1) Replace definitions of two *ProcessTimestamp* functions (OLT and ONU) with one common function:

2) Update the definition of *DRIFT_THOLD* constant.

Figure 144-5—Control Parser state diagram

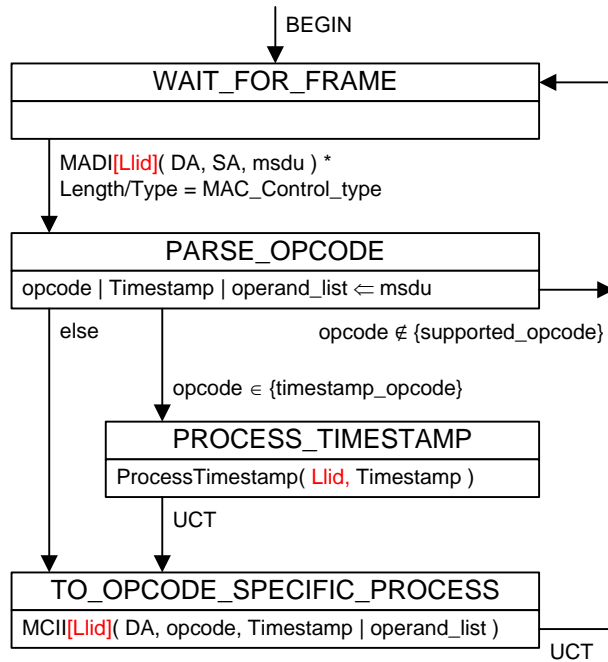
4) Update Control Parser and Control Multiplexor SDs as shown:
